Addendum to Vectrix VX1 owners manual for bikes modified with “The Laird” firmware

This bike has been modified with this charger software and therefore is in better condition than unmodified Vectrix VX1's. Due to the changed charger software the original Vectrix owner manual is no longer applicable in some areas. This addendum addresses these changes.

Chapter 2: Changes to Instrument cluster

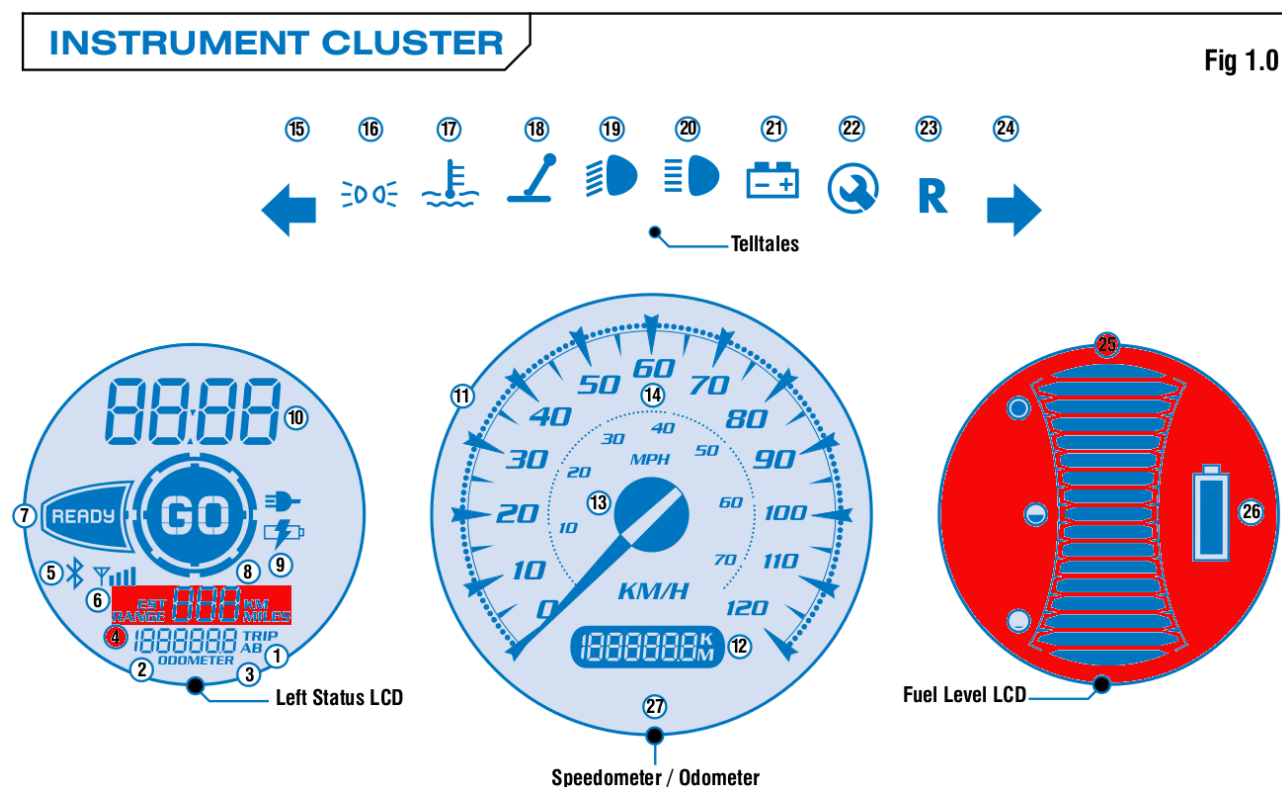
The instrument cluster is shown in below picture and the changed functions are marked in RED.

ITEM 4

- Function in the old software: ESTIMATED RANGE READING
- Function in the modified software: BATTERY PACK VOLTAGE

The result of this change is that the "EST RANGE" and "KM/MILES" text in the instrument cluster have become obsolete and must be discarded.

In the new function of Battery Pack Voltage this field will always show the actual voltage of the battery pack.

ITEM 25

Function in the old software: BATTERY LEVEL INDICATOR

Function in the modified software: BATTERY LEVEL INDICATOR

Although the function itself has not changed the behaviour has. Previously the battery indicator (fuel gauge) would always show all 17 bars illuminated after charging even if the batteries could not hold a full charge. This means that at some point during the ride the bike would fall below its minimum voltage and stop operating while seemingly still have battery capacity.

In the modified software only the actual charge that has been provided into the batteries is added in bars to the fuel gauge. This means that when the batteries are no longer capable of holding a full charge this will be reflected by having not all bars in the fuel gauge illuminated after charging.
